STAFF REPORT

CITY COUNCIL
DATE: 2/20/18
REGULAR
ITEM #: 14

TO: City Council
FROM: Emily Becker, Planning Director
AGENDA ITEM: The Legacy at North Star Preliminary Plat and Planned Unit Development Plans
REVIEWED BY: Ben Prchal, City Planner
Jack Griffin, City Engineer
Ann Pung-Terwedo, Senior Planner, Washington County

THE LEGACY AT NORTH STAR

THE LEGACY AT NORTH STAR - PERIMETER BUFFER EXHIBIT

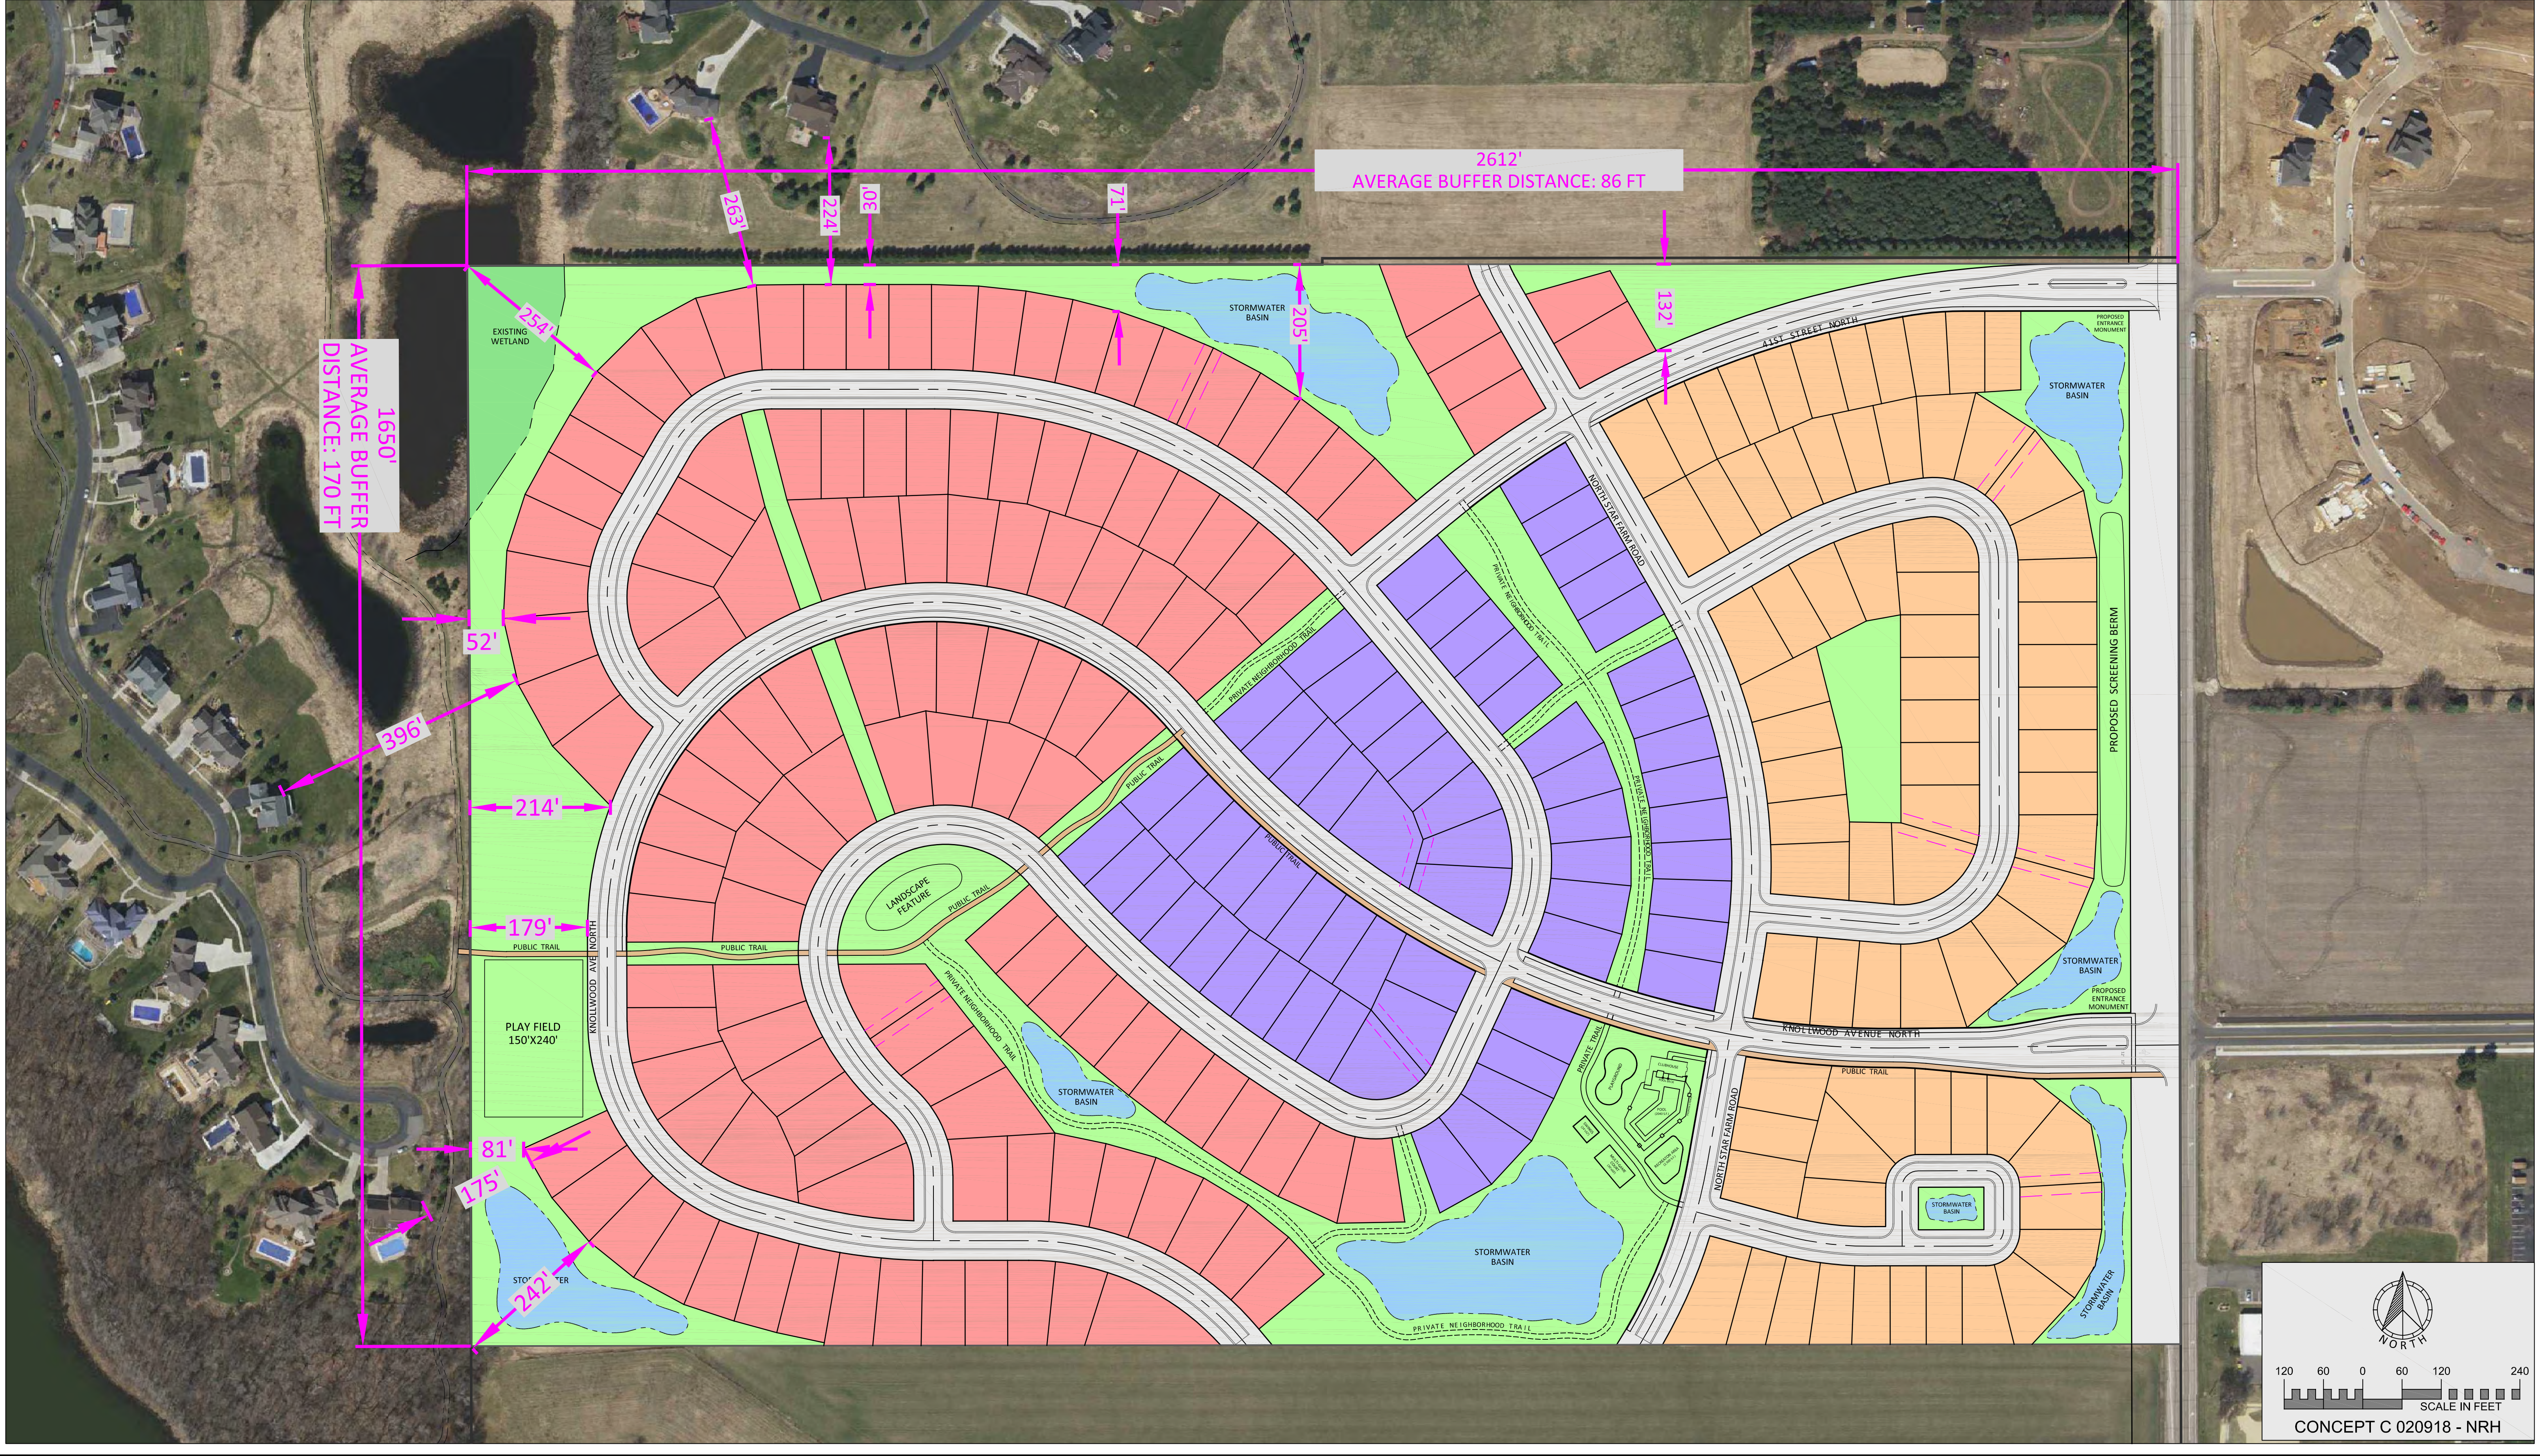
Amended Proposal. The amended proposal provides an averaged 86 foot wide buffer on the northern portion of the plat and an averaged 170 foot buffer on the western portion of the plat, with a minimum of a 30 feet on the norther edge and 50 feet on the western edge. Additionally, it provides 4.43 acres of additional, usable open space. This additional open space is mostly usable whereas the open space within the previous plan was mostly unusable except for the parks.

Staff-Recommended Amendment to Council Amendment. Staff would recommend that the language of the condition read as follows:

11. That the Applicant provide a minimum 30 foot buffer from the northern edges and 50 foot buffer from the western edges of the plat. This buffer shall average 170 feet on the western edge of the plat and 86 feet on the northern edge of the plat and include sufficient landscaping and/or berming as deemed adequate by the City.

THE LEGACY AT NORTH STAR - PHASE 1 LOT SUMMARY

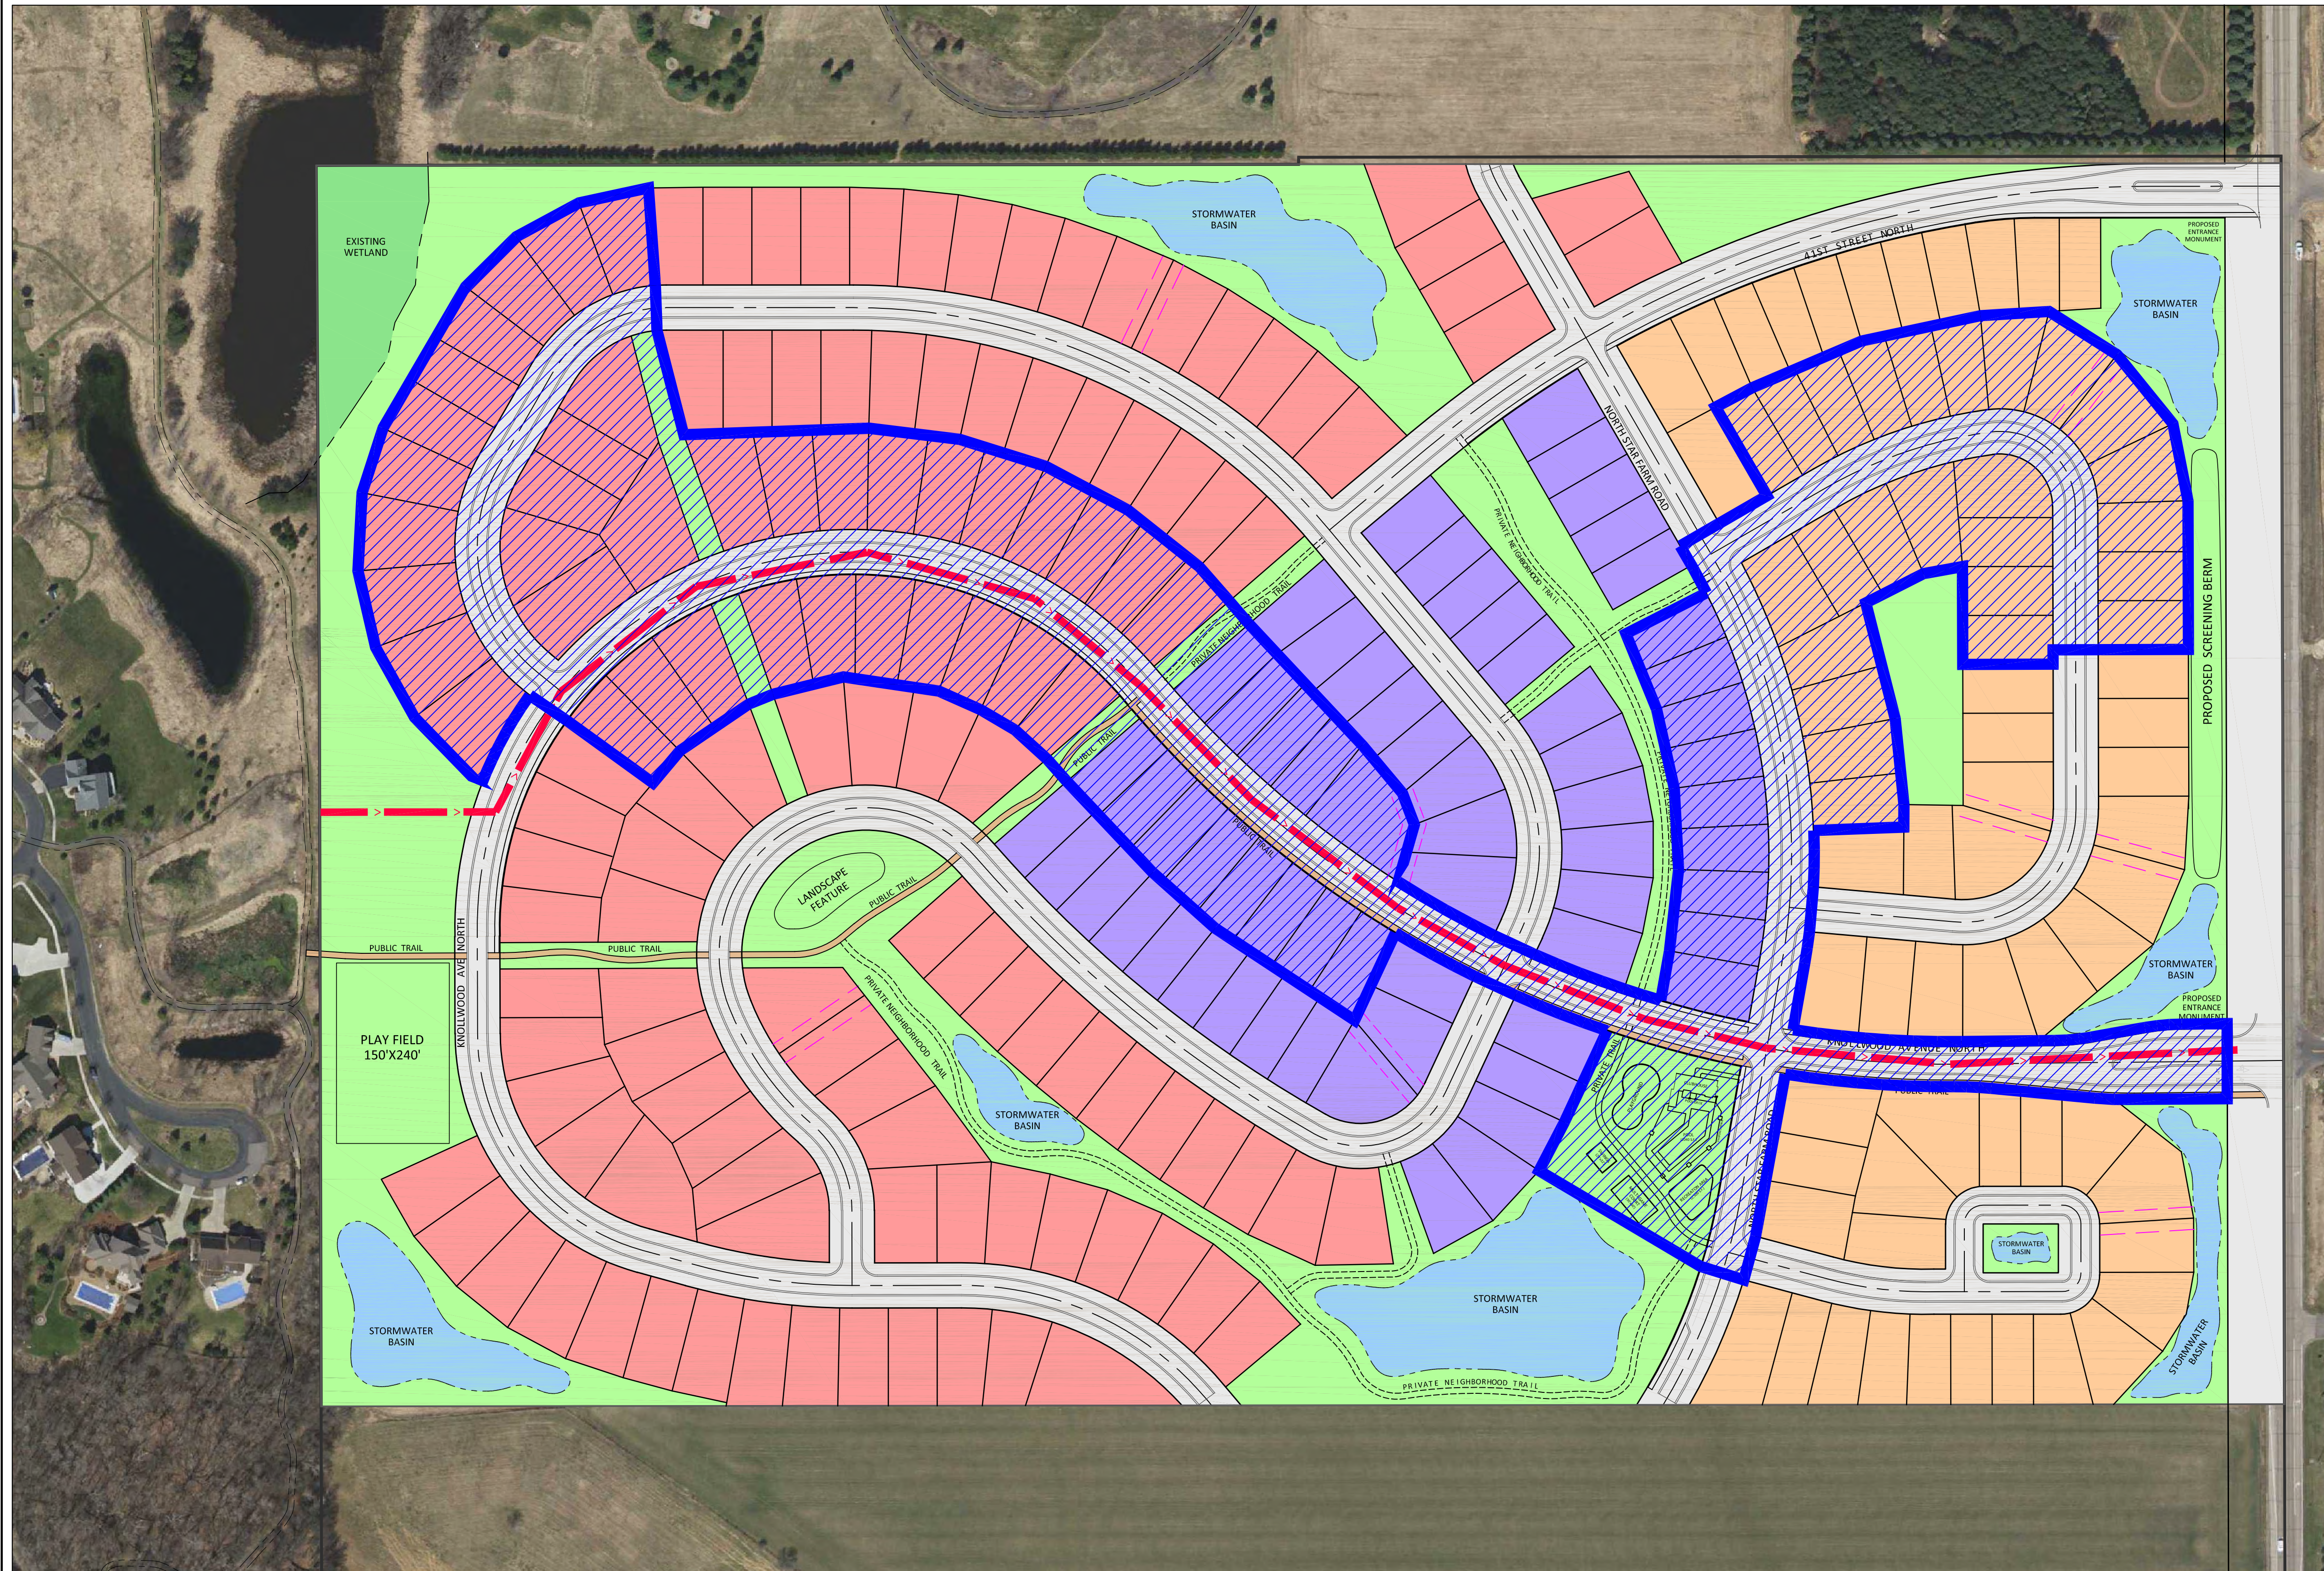
13. That wetlands and wetland buffer areas be contained within outlots outside of lot areas and dedicated to the City.
14. That the Applicant provide a detailed sanitary sewer phasing plan must be provided with Final Plat 1st Addition application to address timely connection to sewer for the wastewater treatment system that includes, at a minimum, dedicated right-of-way or utility easement extended to the westerly side of the plat.
